File: PG5336-LET.03 Revision 1

Subject: **Slope Stability Review and Landslide Risk Assessment
Proposed Multi-Storey Building Complex
1009 Trim Road - Ottawa**

**1015 TWEDDLE ROAD, OTTAWA, ONTARIO
LANDSLIDE HAZARD ASSESSMENT
ADDENDUM**

re: Geotechnical Review - Response to Engineering Comments

Figure 1: Societal Risk Frequency of Landslide vs Number of Fatalities

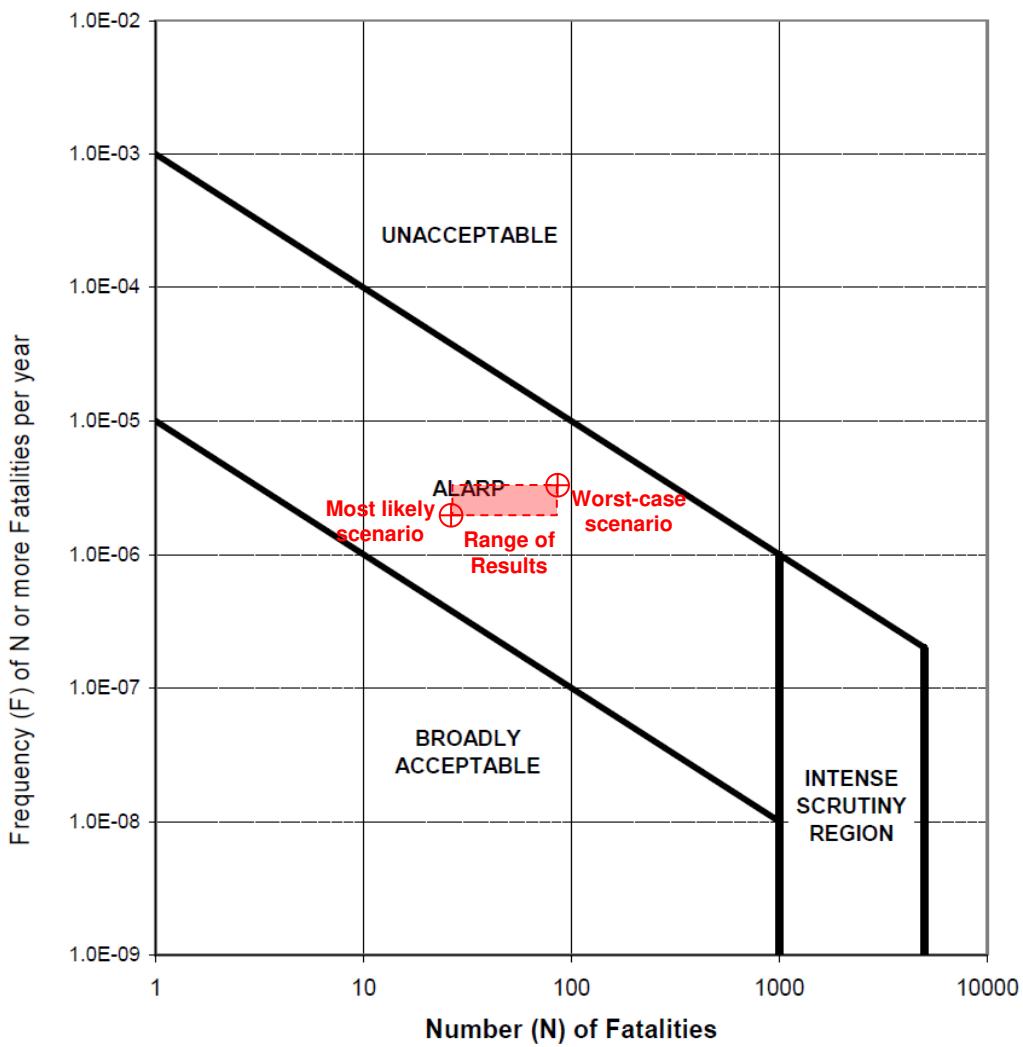
Both of these points are plotted on the F-N graph on Figure 1. Despite the vastly different estimates on probability and number of deaths, the two points still plot in the middle of the ALARP zone, which demonstrates the broad range of risks represented by this zone.
